LAND USE APPLICATION SUMMARY

Project Name: Apartment Building

Prepared By: Aaron Hanauer, Senior City Planner, (612) 673-2494

Request: Apartment Building

SITE PLAN
C2.0

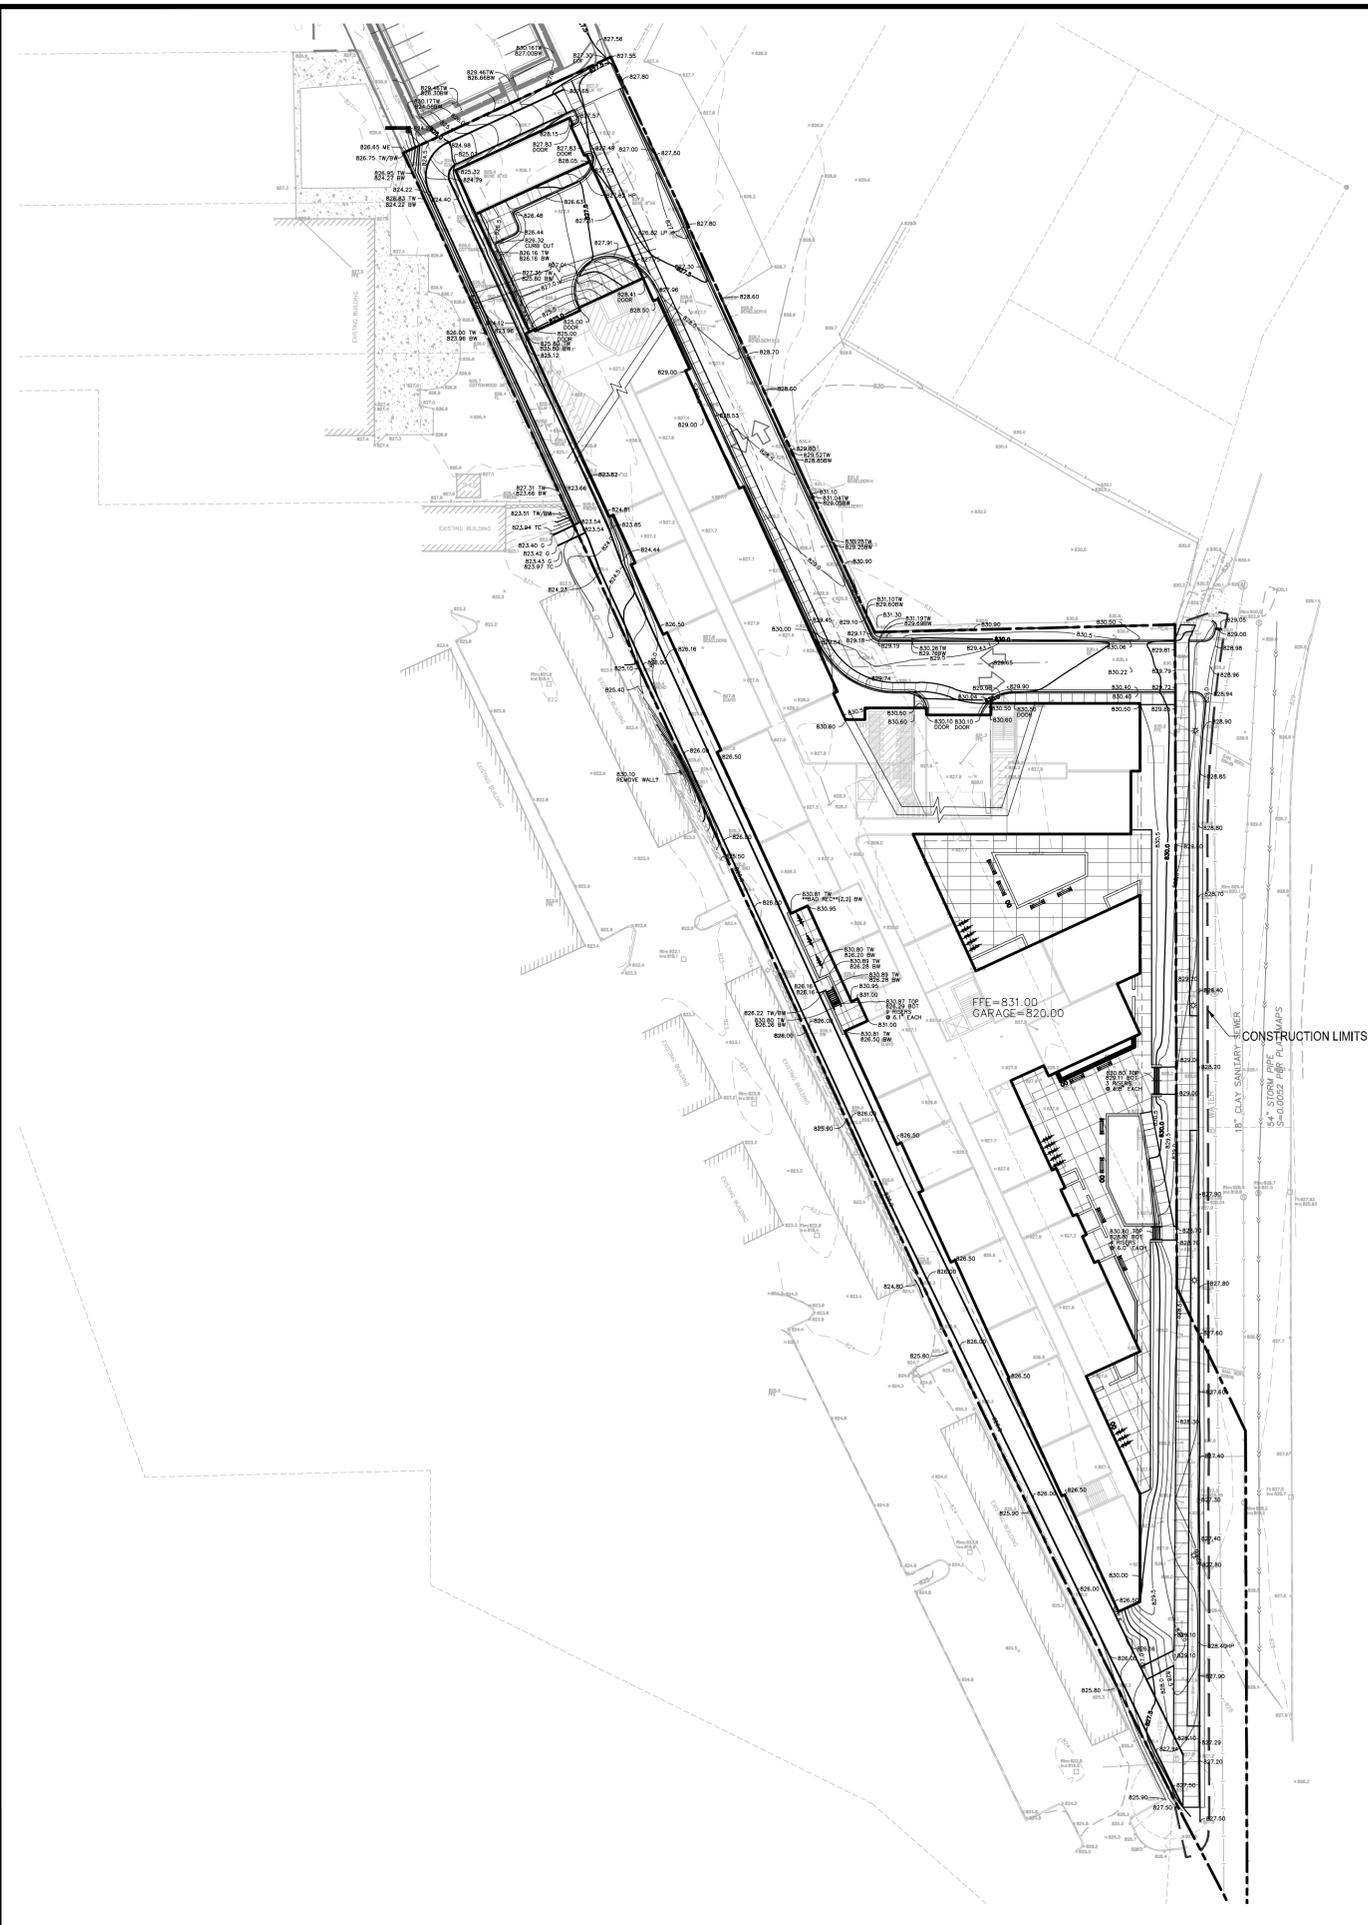
- References to City Standards on Sheet C2.0 shall be specific and refer to the appropriate details elsewhere in the plans.
- All driveway aprons shall be designed and constructed to City standards. All driveway aprons shall be shown graphically correct on all related plan sheets. The Minneapolis Standard driveway apron provides for 5' curb radii; the current plan shows curb cut radii of 15' which exceeds the standard and shall be revised appropriately.
- All curb & gutter in the Public right-of-way shall be designed and constructed to City standards, curb & gutter to be City standard B624 Curb and Gutter.
